> RE: Letter of Explanation Application for Variance 823 Buckingham Drive Severna Park, MD 21146

PROJECT NOTIFICATION APPLICATION

CONFIRMATION OF PRE-FILE

Comment Responses for 2025-0003-P at 823 Buckingham Dr

SETBACKS (ZONED R2)

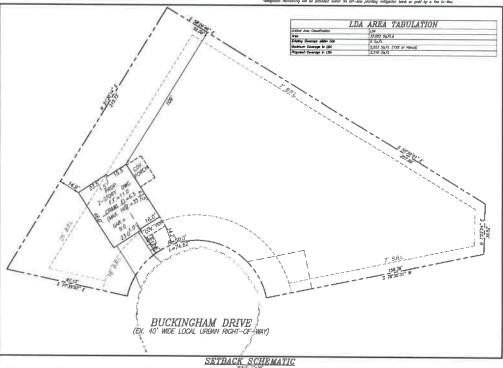
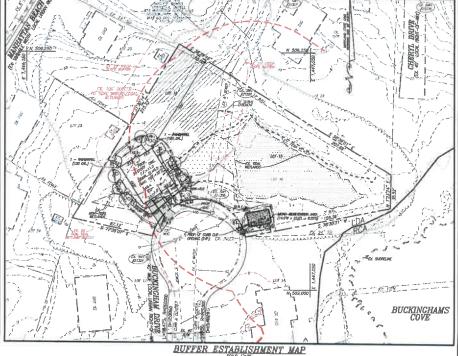
The setbacks shown on the plan are incorrect and the western property line would be considered a rear property line with a 25' setback.

Correct the site plan to reflect the northwest lot line to be a rear lot line and to correct the setback for the lot line that abuts Cheryl Drive as a front (30' setback). This property has dual frontage.

Acknowledged. The setback has been corrected on the site plan. See Site Plan.

The address has been corrected to state 823 Buckingham Drive. The setbacks have been corrected on the site plan. See Site Plan.
